**Request for Reconsideration:**

Appl'n No. 10/053,582  
Amd't Dated Feb. 1, 2005  
Reply to Office Action of Dec. 9, 2004  
Annotated Sheet Showing Changes

**Fig. 3** ← RENUMBER  
FIG. 2 SUBMITTED  
08/10/04, AS FIG. 3

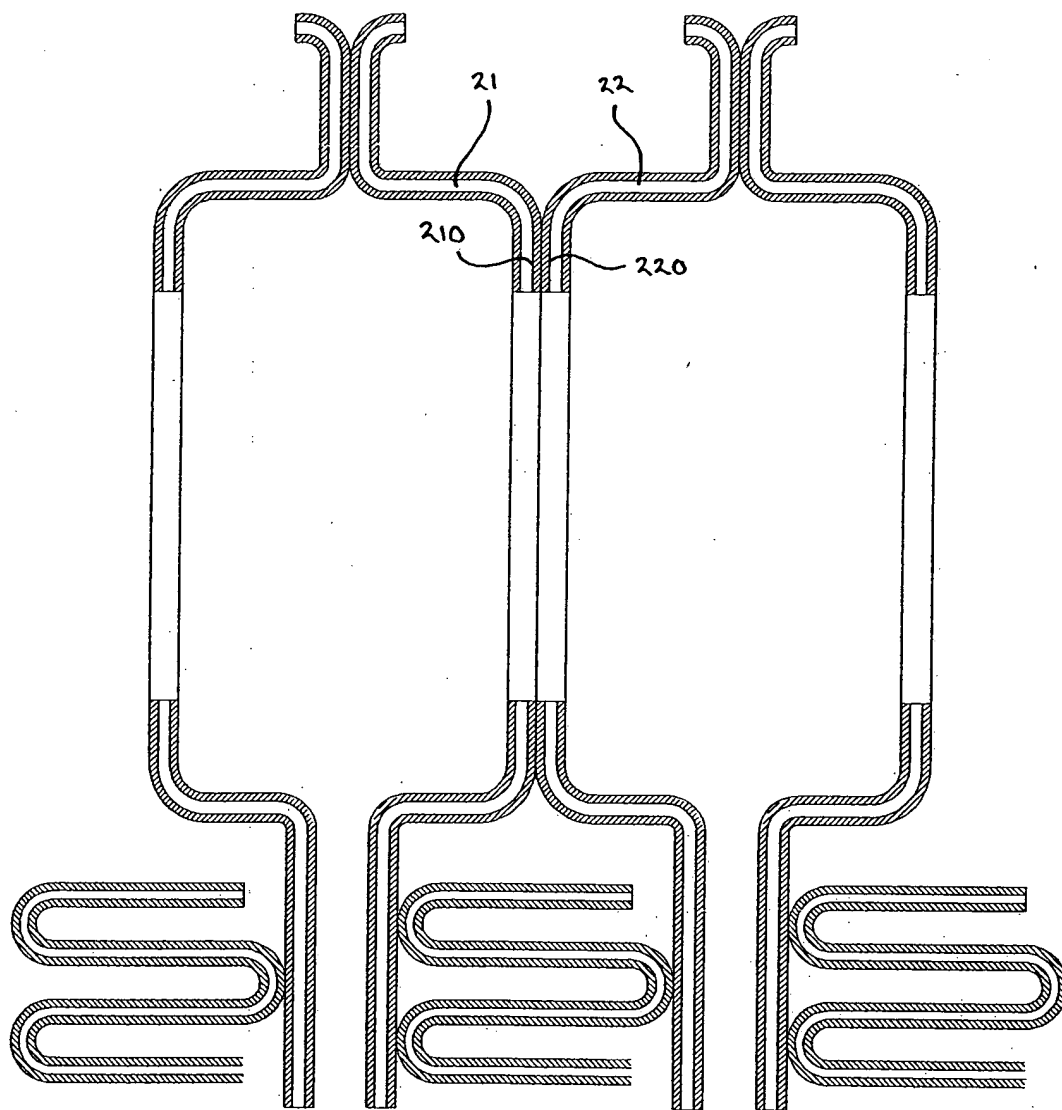
The attached sheet of drawings rennumbers **Fig. 2**, which was submitted in the Responsive Amendment filed August 10, 2004, as **Fig. 3**. This sheet, which includes renumbered **Fig. 3**, replaces the original sheet including **Fig. 2**.
